Special inspection to increase the TBO for engine

Mandatory

- Subject:** Increase of TBO from 600^h/10 years to 1000^h/10 years.
- Engines affected:** Generally all engines of Series Type 912 A up to and including engine N. 4,076.191 in accordance with Type Certificate TW 8/89, with the exception of V912/1983, V912/1920, 3,792.605, 3,792.701, 3,792.788, 3,792.789, 3,792.790, 4,005.013, 4,005.083, 4,005.133. From engine N. 4,076.192 onwards the 1000^h TBO is covered by TM 912-04.

2.1) Friction washer, amendment no. 15:

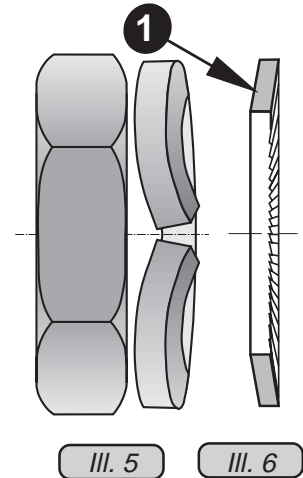
If hex. nut is still secured by a lock washer, it has to be exchanged for the friction washer ①. Slide drive gear of the exchange gearbox on cleaned serration of crankshaft and fit friction washer and hex. nut M30x1,5.

■ **ATTENTION:** Secure hex. nut with LOCTITE 221. Hex. nut with L.H. thread.

3) Oil pump amendment no. 17, 22 and 32-17:

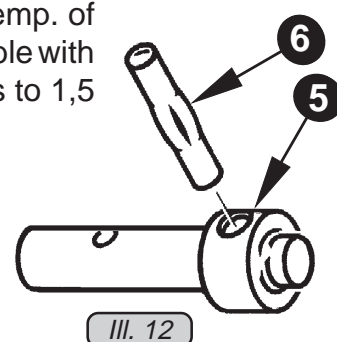
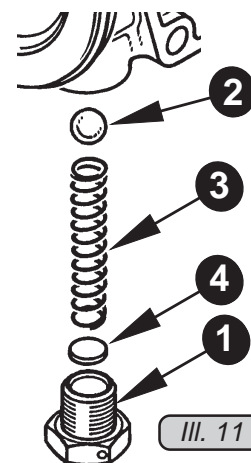
Remove plug screw ① of pressure relief valve ②, clean valve and check ball seat in housing. Clear all oil passages by compressed air. From engine serial no. 4,005.186 onwards, to improve oil pressure control the following parameters of the relief valve were changed. Free length of the compression spring ③ was reduced from 46 mm to 39,5 mm. Spring rate was changed by increase of wire dia. from 0,8 mm to 0,9 mm, and dia. of ball was increased from 8 mm to 8,5 mm.

◆ **NOTE:** Starting with engine N. 3,792.944 the oil pump housing and oil pump cover is in pressure die cast. On this occasion capacity of the pump was increased by lengthening of the rotary piston assy. from 13 mm to 16 mm along with the respective changes of oil pump housing, pump shaft and O-rings.

From engine serial no. 4,076.068 onward the follower in the oil pump shaft ⑤ was changed to notched pin ⑥ instead of the former dowel tube.

At a renewal of components change oil pump to the version with the 16 mm long rotors.

4) Rubber plate, amendment no. 32-19

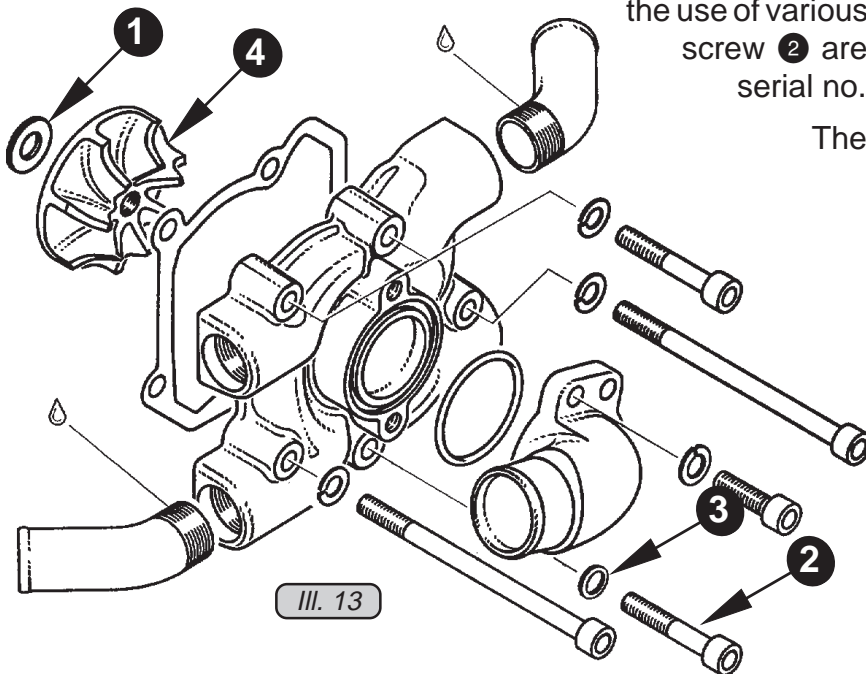
To prevent chafing of the expansion tank a protective rubber plate is glued to underside of expansion tank since May 1993. Inspect expansion tank and stick rubber plate to underside of tank.
